AGENDA

City of Sedona Planning and Zoning Commission Meeting

Item 3:
Oak Creek Boulevard Multifamily
PZ18-00004 (ZC, DEV)
Conceptual Review

Staff Report
 PZ18-00003 (SUB)
 Hillside Vista Estates
 Summary Sheet

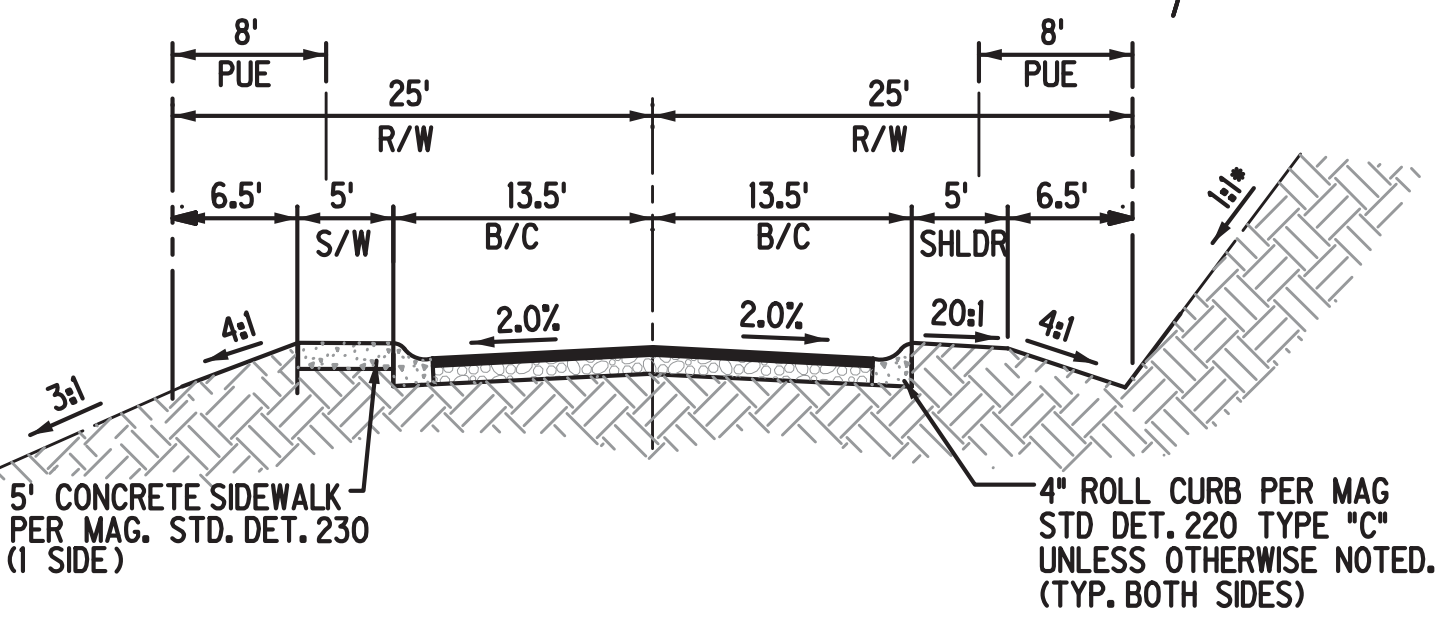
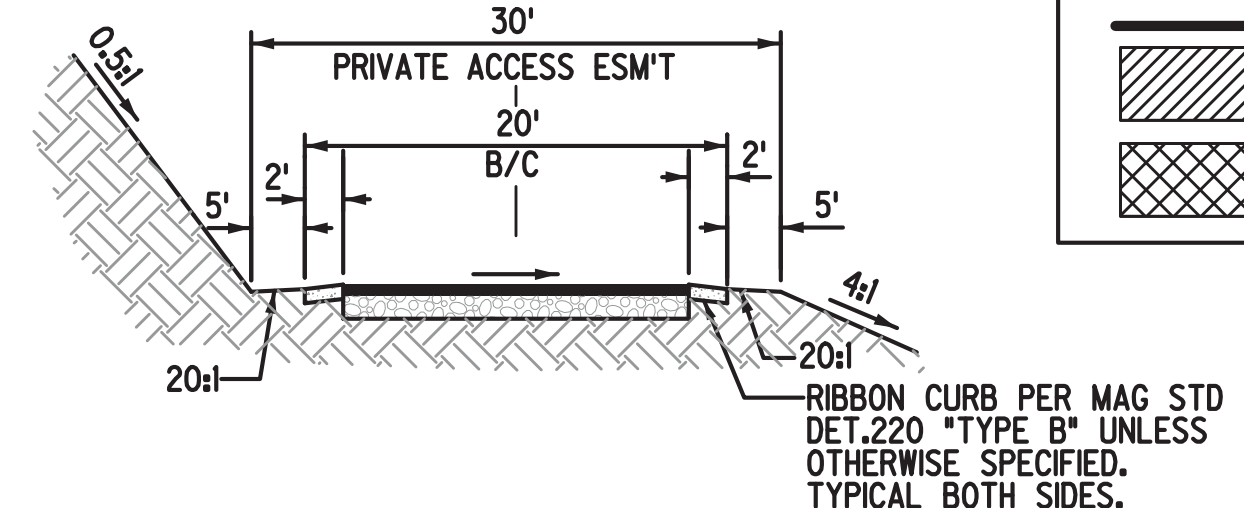
- a) The RS-35 zoning district requires the following minimum setbacks: Front and Rear Yards: 40 feet; Side yards: 20 feet. While it appears that many of the building envelopes shown follow these setbacks, there are a number of lots that have more restrictive envelopes due to drainage ways, rock outcroppings, and other site constraints. Where there are additional restrictions on the building envelope, please provide details, including measurements, so that these areas may be properly applied to future development of the lots. Ideally, this would be done on a separate sheet that would show an enlarged plan for each of the affected lots.
- b) Please include dimensions for all private access drives/shared driveway easements.

- d) Front yard setbacks are measured from the property line or the easement providing access to the property. Please modify the building envelopes on Lots 7, 16, 17, 18, 27, and 28, to provide a minimum of 40 foot setback from the edge of the access easement.

4. Property Owner's Map and Topographic Map
 - a) The property owner's map and topographic map shows the easement providing access to Lots 6, 7, 27, and 28 extending to also provide access to Lots 29 and 30. This extension is not shown on the Conceptual Plat. Please ensure all maps show the same easements.
